# METAL CRAFT

Company:  
Plenty Unlimited Inc

# PROOF

Quote #: 210597

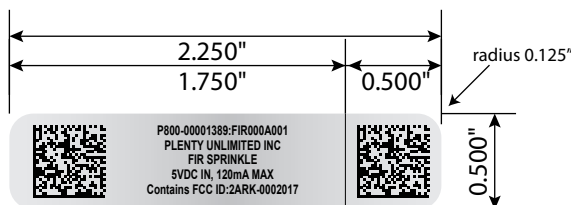
Could not match print exact:

Text is 5 Arial Bold Font, not 8 in order to fit within textbox.  
Textbox is about .372 tall, not .394 to fit within our tolerances.  
Barcodes are .375, not .394 to fit within our tolerances.
